## **APPLICATION REVIEW**

Public Works has the following concerns;

Figure 1

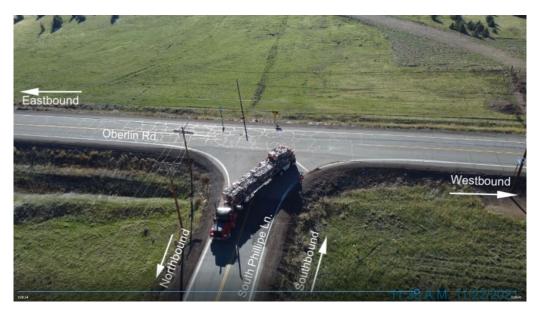
1.) According to table 8 of the Initial Study Checklist dated July 2021, there will be 40 truck trips (80 in/out total). It is presumed that these 80 trips could affect both the northerly parcel with the truck scales, as well as the southerly parcel with the recycling facility, as construction materials are generally paid for by weight and haul trucks need to be weighed before and after loading. The traffic routing between the north and south parcel has not been described. It is very difficult to condition the routing of vehicles once driveways are permitted. It has to be assumed that all of the trucks trips between the north and south parcel will be via. the South Phillipe Lane intersection as a worst case scenario. Public Works is concerned that the increase in truck traffic from this proposed project will exacerbate the existing hazards associated with this intersection which was not originally designed to accommodate large truck turning motions without crossing into opposing traffic (see Figures 1 & 2).

- Widening the South Phillipe Lane intersection to accommodate large truck turning motions.
- Eliminating the dogleg in the traffic flow by relocating the southerly access road to align with South Phillipe Lane. This realignment would require relocation of a utility pole and potentially placement or relocation of a roadside sign.

Figure 4

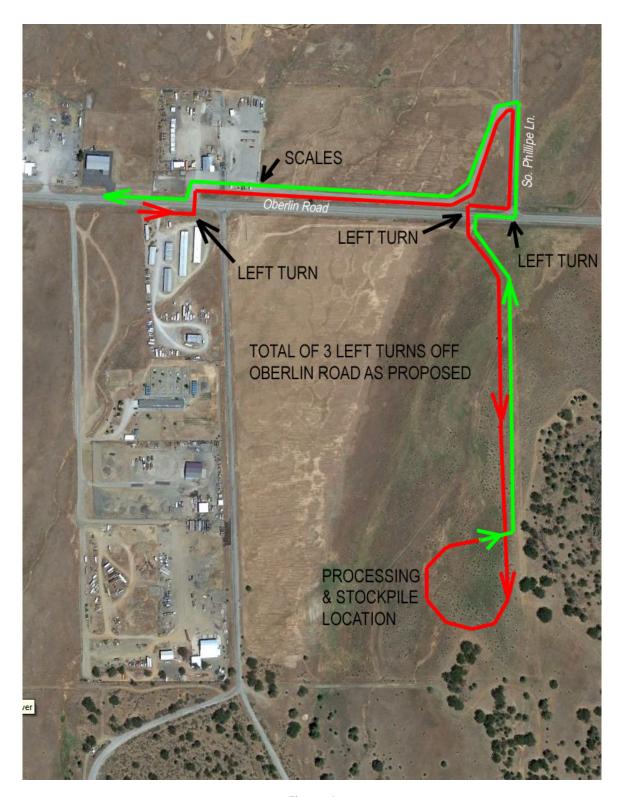
- 2.) Public Works is concerned that the dogleg in the traffic flow between the northerly parcel and the southerly parcel results in two potentially avoidable hazardous left turn motions off of Oberlin Road. Left turn-involved accidents (angle, rear-end, and same direction sideswipe) account for a significant percentage of intersection accidents at all types of intersections. The Siskiyou County Local Roads Safety Plan ranks Oberlin Road as #5 on the list of county maintained roads with the most traffic accidents between 2017 and 2019. A review of vehicle accident reports showed 20 accidents in this vicinity of South Phillipe and Oberlin Road between 2011 and 2019.

Using the number of truck trips provided in table 8, of the Initial Study Checklist, on average there will be a truck entering or leaving the proposed southerly access road every 7.5 minutes. It has to be assumed each of these 40 round trips will involve at least three left-turns off of Oberlin Road (See figure 4).

- Constructing an engineered left turn pocket on Oberlin Road near the intersection of South Phillipe Lane.
- Removing the dogleg in the traffic flow by relocating the proposed southerly access road to line up with the South Phillipe Lane and Oberlin Road intersection. Doing this would eliminate two of the left turns off Oberlin Road.
- Relocating the southerly access road and placing the truck scales on the southerly parcel.
